| GAUGE FOR INSPECTION | | | | | |
| CHECKED BY :- <i>TRAB</i> | PUNCH, BLANKING | | GOK1A | | |

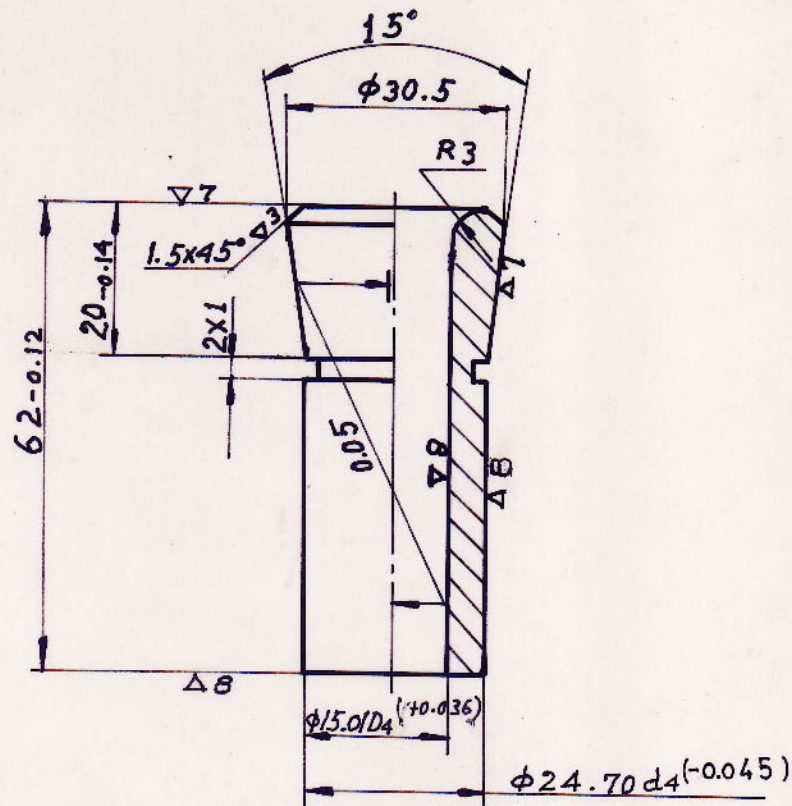
3. ORIGINAL DIMENSION $\phi 24.59D_4 (-0.045)$ WAS CHANGED TO $24.70D_4 (-0.045)$ IN PENCIL HAND WRITING BY CHINESE EXPERT.
